REPORT TO COUNCIL

Application: DP17-0231 DVP17-0232

Address: 3626 Mission Springs Drive

Subject: Development Permit and Development Variance Permit

Figure 1: Proposed Site Plan

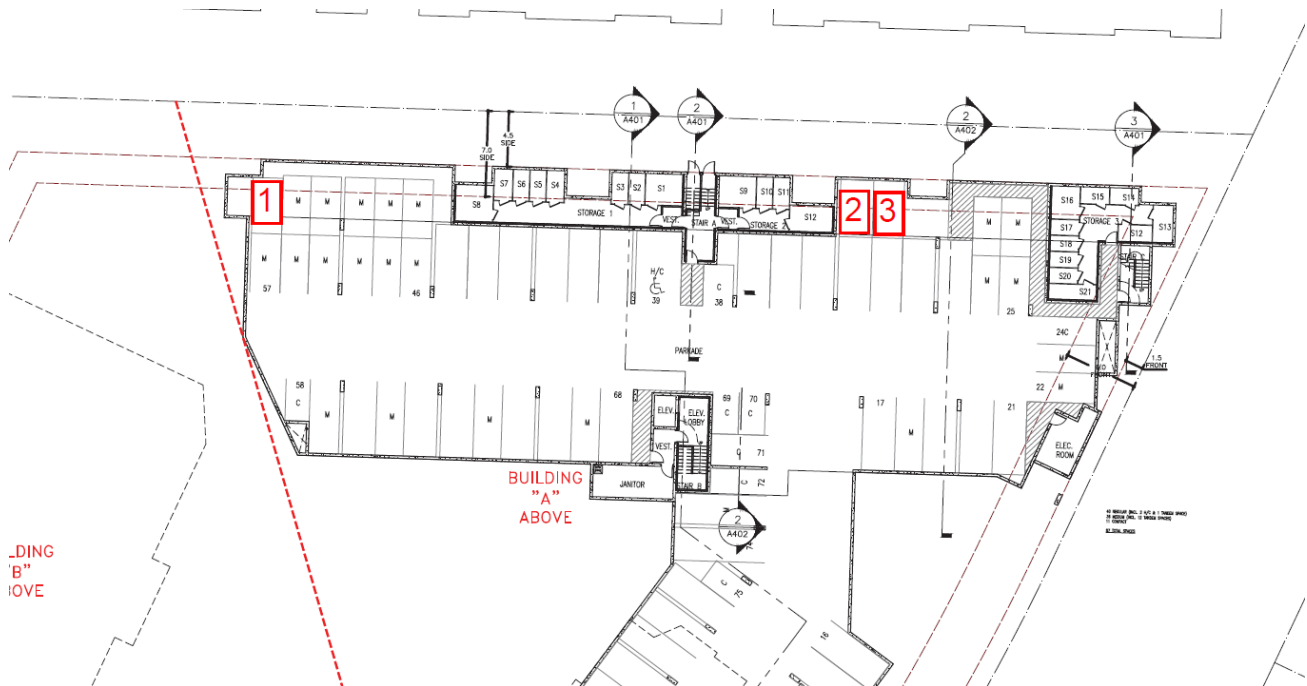
- Fire Department access is to be met as per BCBC 3.2.5. including the main entrance to be within 3m-15m from the closest access route.
- Building B appears to have a challenging access for a ladder truck with the road being constructed from reinforced turf. The turf must support the weight of a truck at 38,500 KG including during periods of significant rain and/or snow.

- Access to building B is unsafe for firefighting. The close proximity of the NE corner of Building B and west side of Building A would leave Building B unprotected in a fire event. A truck would NOT be committed to this confined space. As recently seen in the Truswell fire, adjacent buildings are vulnerable while under construction even when the Fire Department does have access. The collapse zone of building A and B would hinder chance of access to Building B.
